FERMILAB  
ENGINEERING NOTE

HAMMOND ENCLOSURE DRILL PATTERN

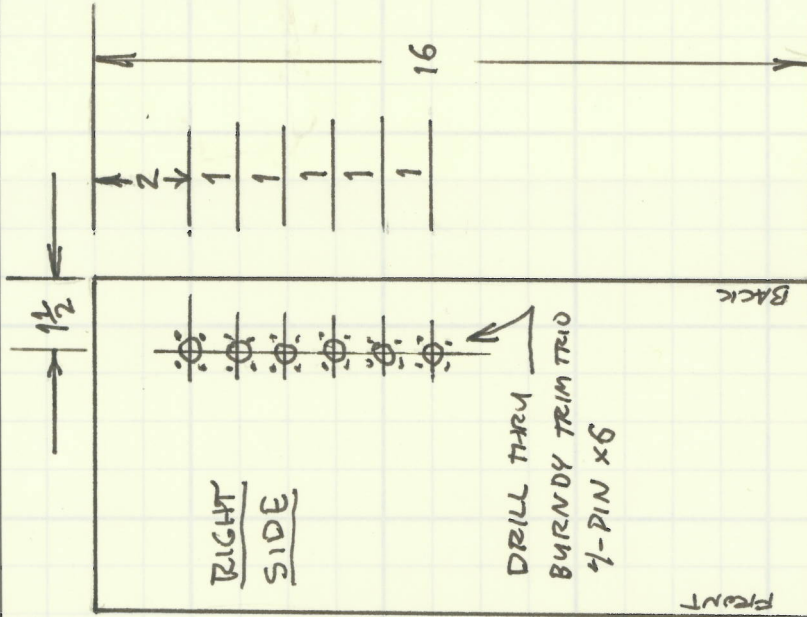
This hole should be a bit smaller than 1 inch. It is for a grommet, and we're using the largest stockroom grommet. It swims around a bit in a 1 inch hole. maybe 15/16"? whatever works.
